5 West Lenox, Cherry Chase

## HISTORIC PRESERVATION COMMISSION

SUBJECT: Historic Area Work Permit #522831, alterations, to building and hardscape

**MONTGOMERY COUNTY HISTORIC PRESERVATION COMMISSION**  
**STAFF REPORT**

5 West Street c. 1912

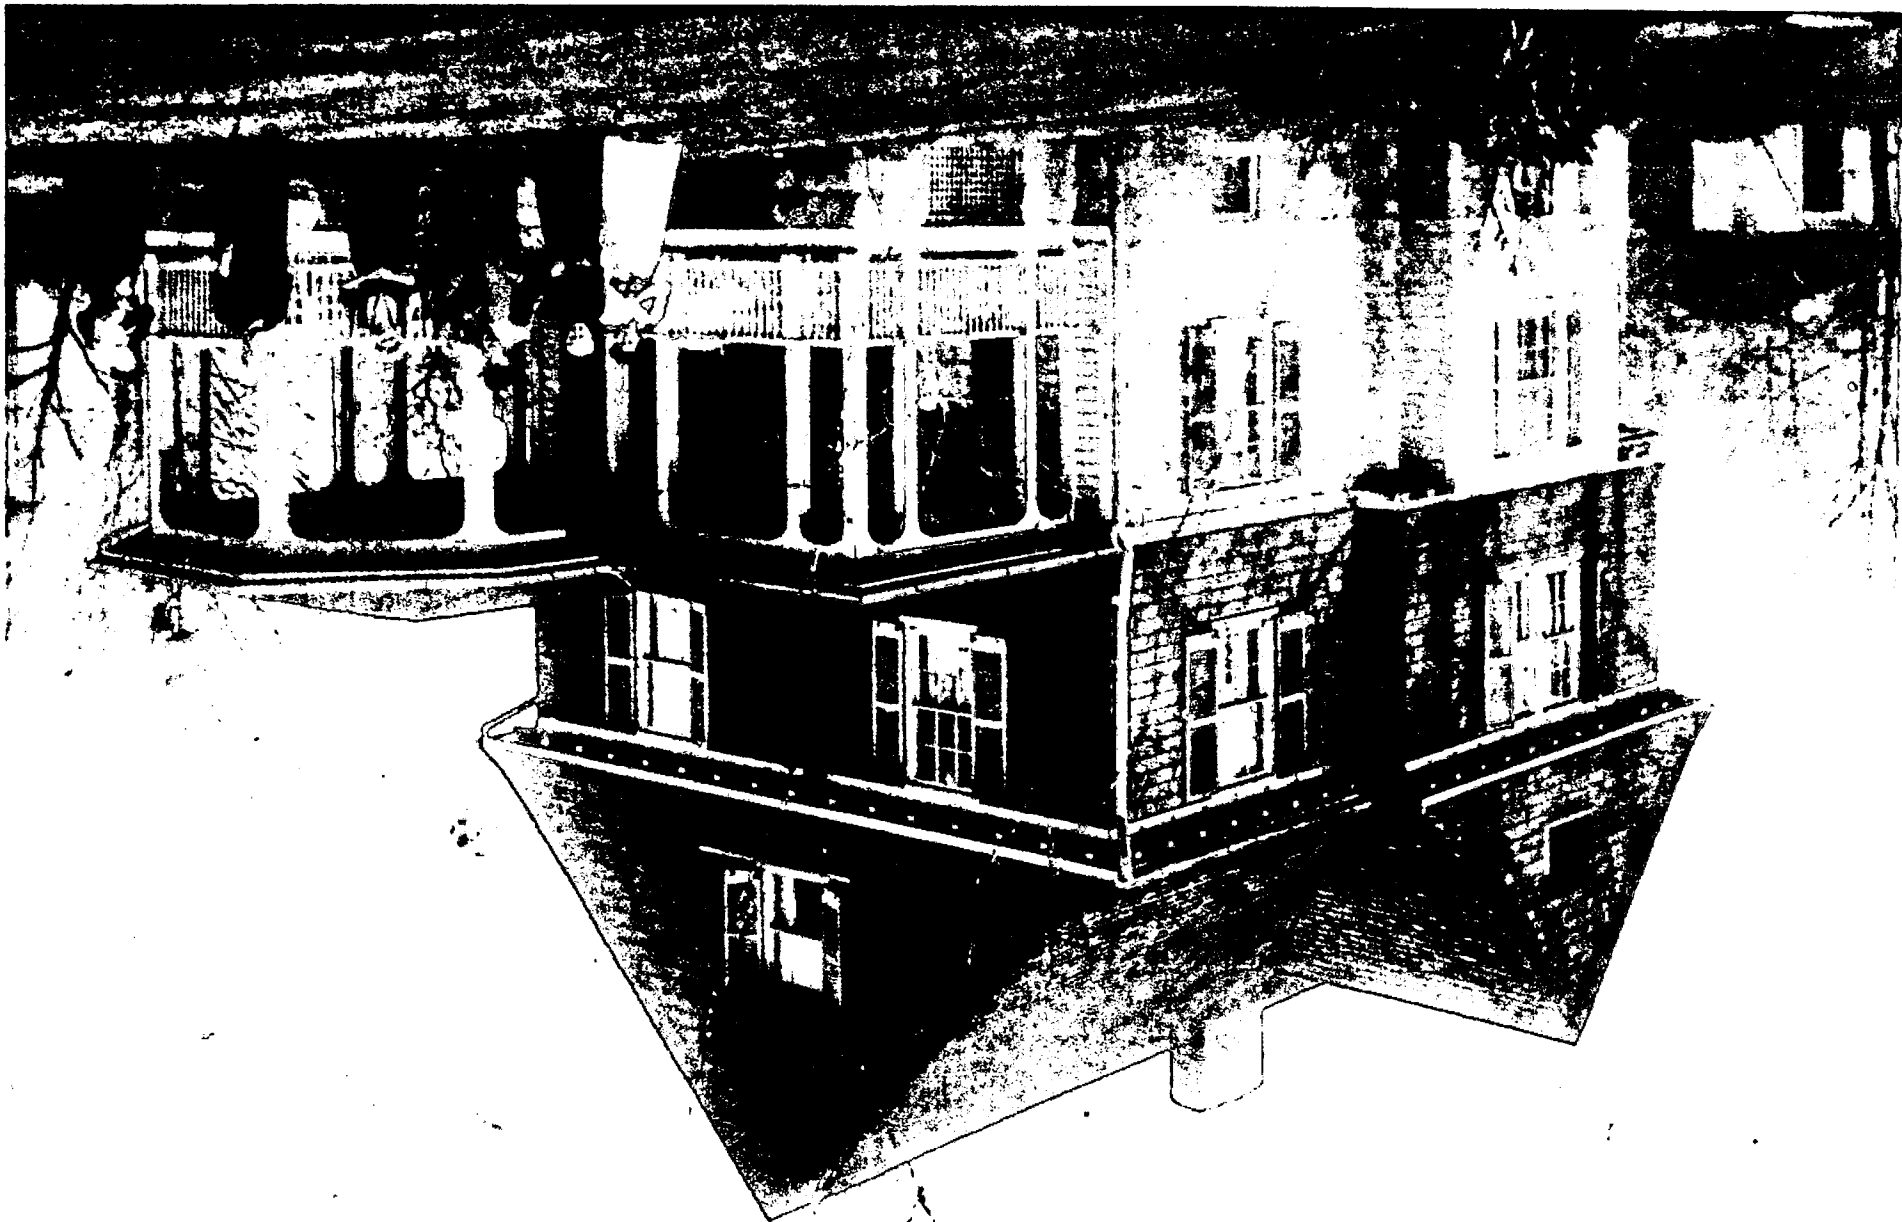
4. Remove an existing clapboard wall patch from the front elevation of the house and install a true divided light wooden French door system. The applicant has provided historic photographic evidence that documents the presence of a French door system in this location [SEE CIRCLE 36]

The applicant has provided historic photographic evidence that substantiates the presence of a missing French door system that was located on the front elevation. The proposed removal of an existing clapboard wall patch and installation of a wooden true divided light French door system and shutters is consistent with the historic photo.
